More on the proposed desecration of Glen Etive

Notifications that two of the Glen Etive hydro applications had been withdrawn were issued by Highland Council last week but, before anyone celebrates, they have been replaced with new applications for the Allt Mheuran and the Allt Fhaolain. That re-starts the whole planning process. If you objected first time round, that objection is no longer valid. If you did not manage to comment then, now is your opportunity!

A new access track (in area outlined in red) will connect the existing forest track with the intake

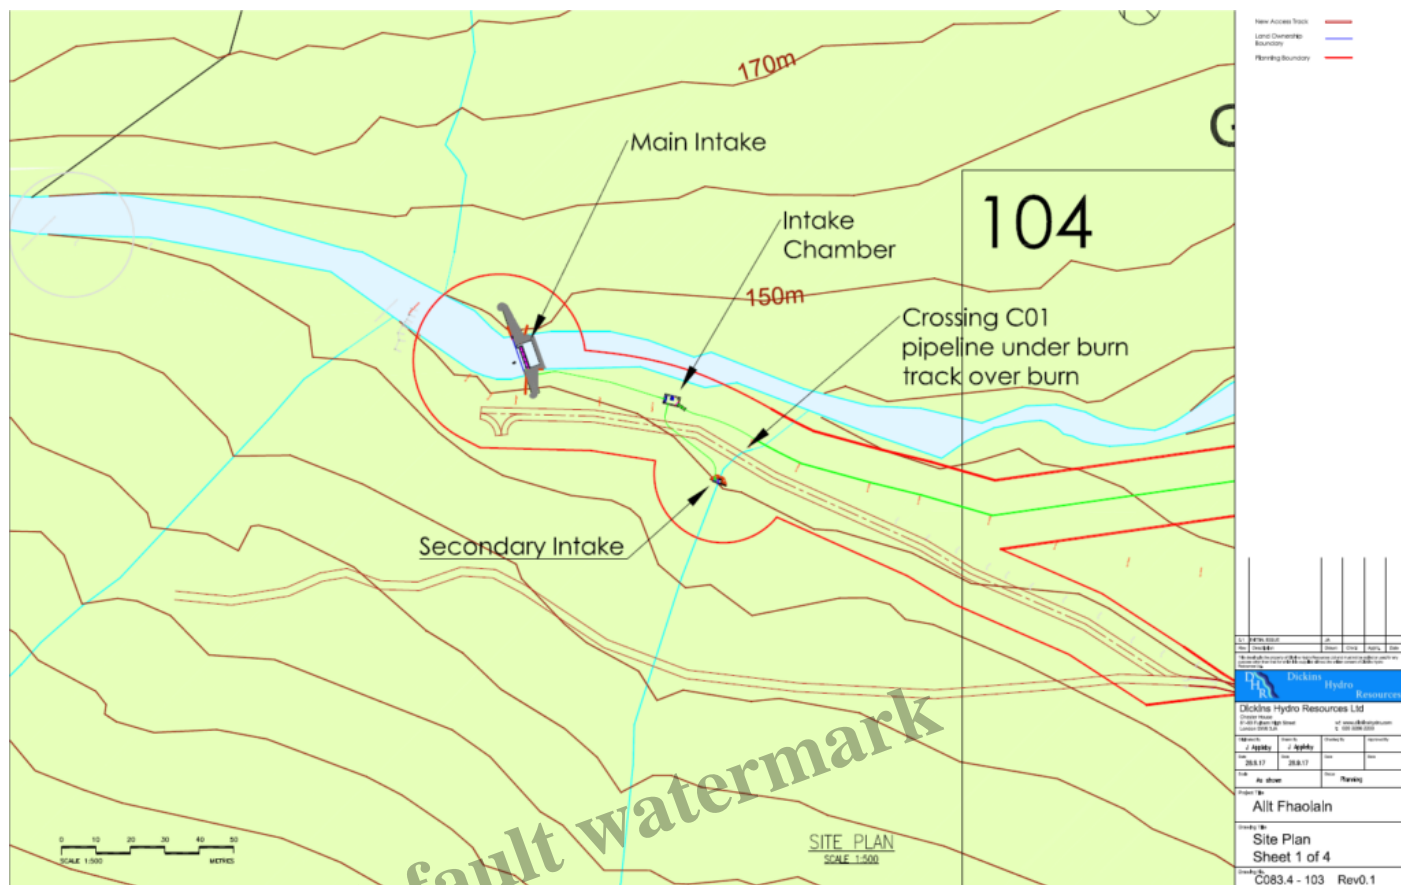
Ancient woodland runs along the Allt Fhaolain and the scheme will destroy some of this in its upper reaches, like the other schemes on the west side of the River Etive. There is still no proper assessment of the impact of these schemes on native woodland or on the scenery as the forest plantations are felled.

The existing “track is to be upgraded, including the replacement of any culverts that require it with bottomless culverts. A new access track is to be created from the existing forestry road to the intake. This will be reinstated at the end of construction to an ATV track”. Its not clear what the proposals to “upgrade” the existing forest track mean. Will it end up wider than at present? The phrasing of the application suggests it won’t be narrowed to ATV width. And why does the new ATV track need to be retained? Its only 150m long so turn it into a footpath. It would take 5 minutes for staff to walk it.
